TO: DEVELOPMENT REVIEW BOARD
FROM: CURRENT PLANNING SERVICES
SUBJECT: CASE 69-DR-2003
REQUEST: Approve site plan & elevations for new grocery store and drug store to replace existing buildings
PROJECT NAME: Bashas Shopping Center
LOCATION: 8035 E Indian School Rd

DATE: November 20, 2003

Stipulations for Case: Basha's Shopping Center 69-DR-2003

A0.1

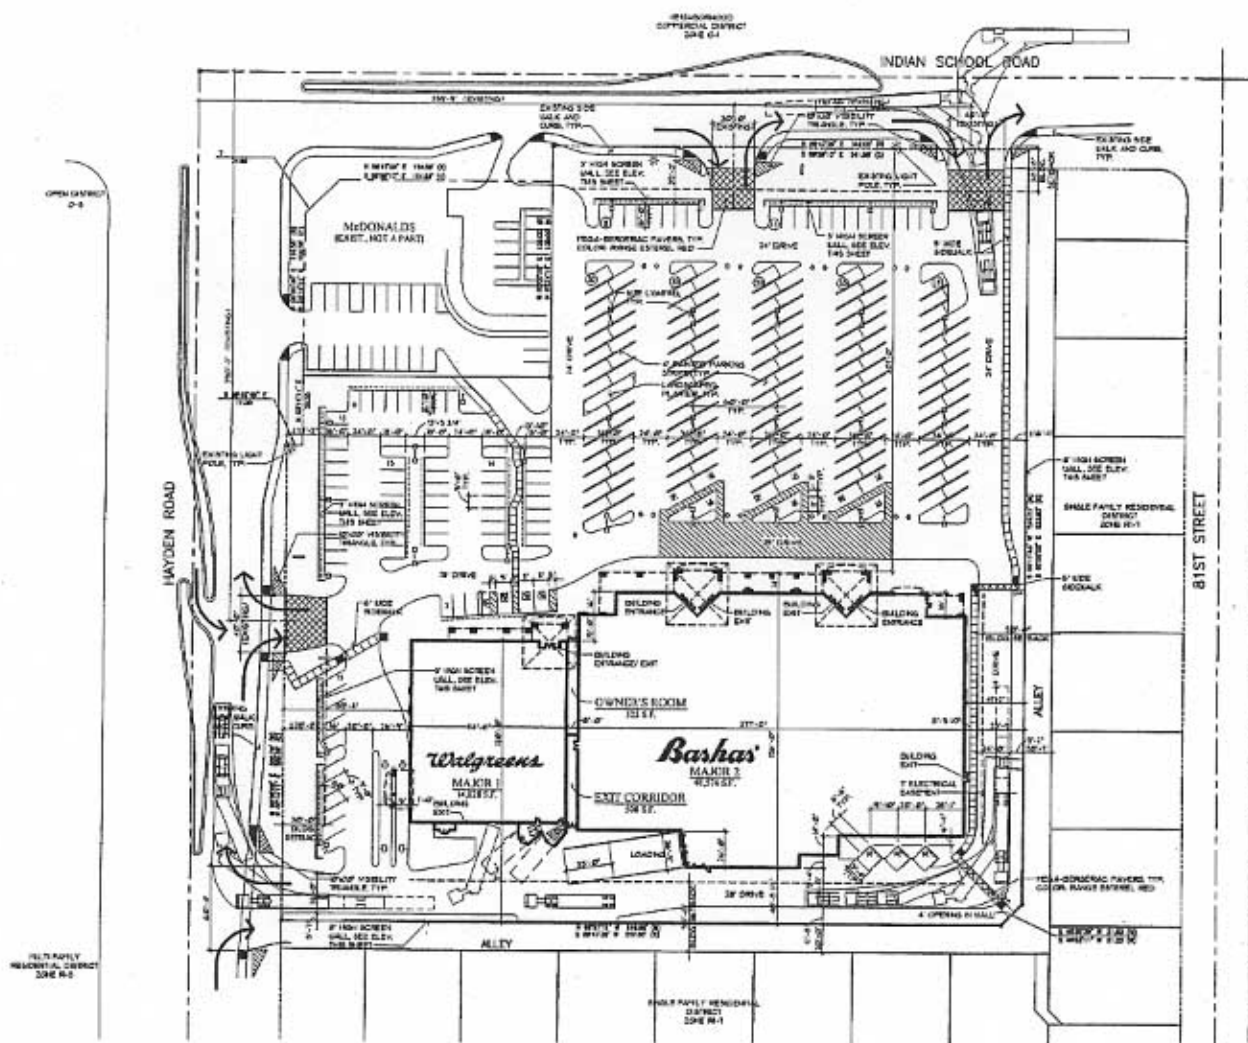
- b. The location and configuration of all site improvements shall be constructed to be consistent with the site plan submitted by Butler Design Group (Bdg) dated 11/3/2003 by City staff.

- 18. A new 8-foot tall perimeter wall shall be provided along the south and east property lines, except at approved openings coordinated with the neighborhood.
- 19. All screen and perimeter walls shall be 6 or 8-inch masonry block and shall match building texture and color, both sides. Dooley wall fencing shall not be allowed for the perimeter wall.
- 20. Flagpoles, if provided, shall be one piece, conical, and tapered.

Conceptual Landscape Plan

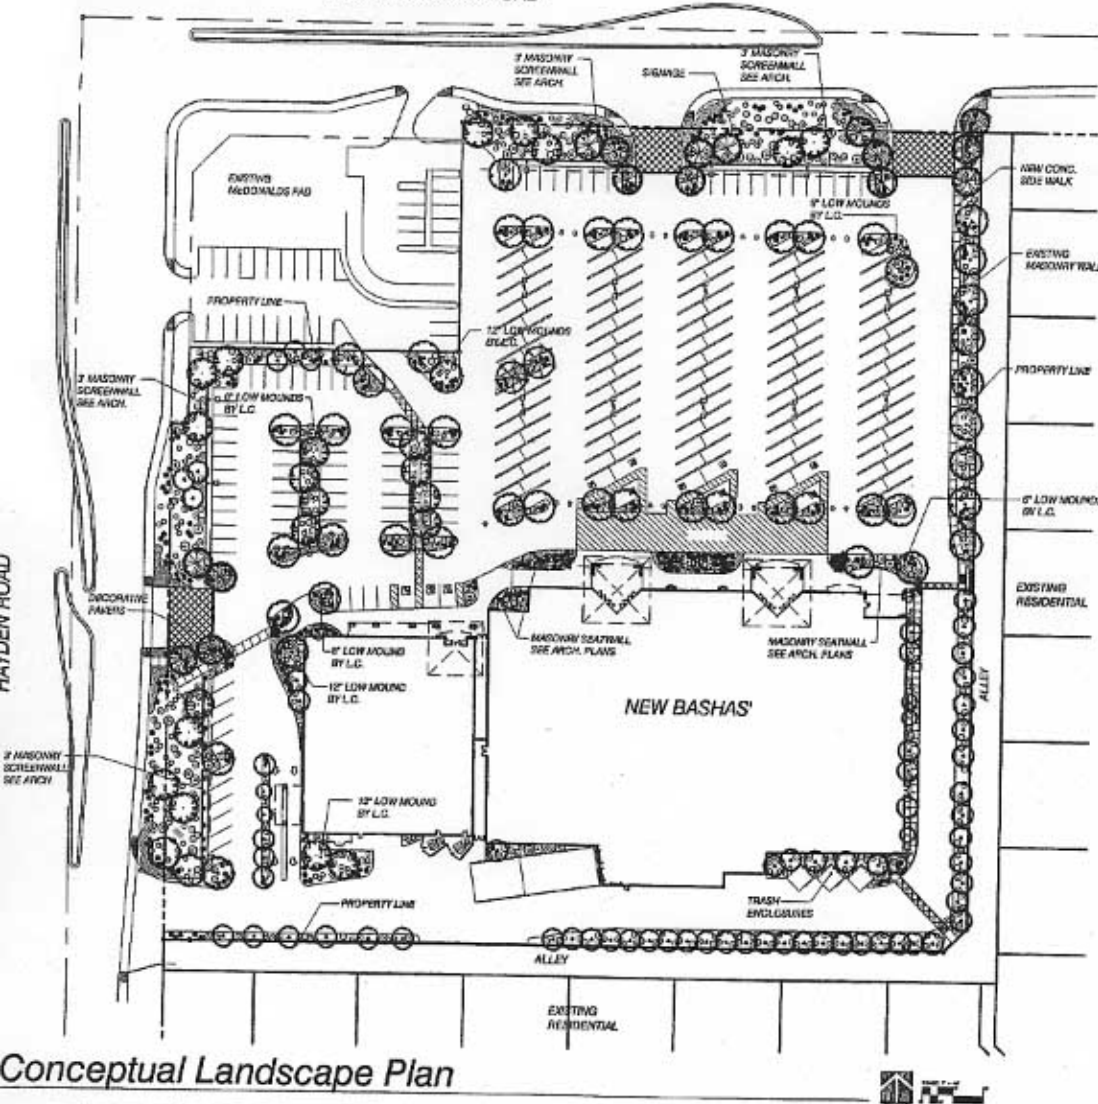
- c. Landscaping, including quantity, size, and location of materials shall be installed to be consistent with the conceptual landscape plan submitted by Laskin & Associates, Inc dated 11/3/2003 by City staff.

- 10. Landscape pots (36-inch diameter minimum and irrigated) and seating areas shall be provided along the storefront frontage if included in the open space calculation, to the satisfaction of plan review staff.
- 11. Upon removal of the salvageable native plants the salvage contractor shall submit completed Native Plant Tracking Form as well as a list identifying the tag numbers of the plants surviving salvage operations to the City's Inspection Services Unit within 3 months from the beginning of salvage operations and/or prior to the issuance of the Certificate of Occupancy.
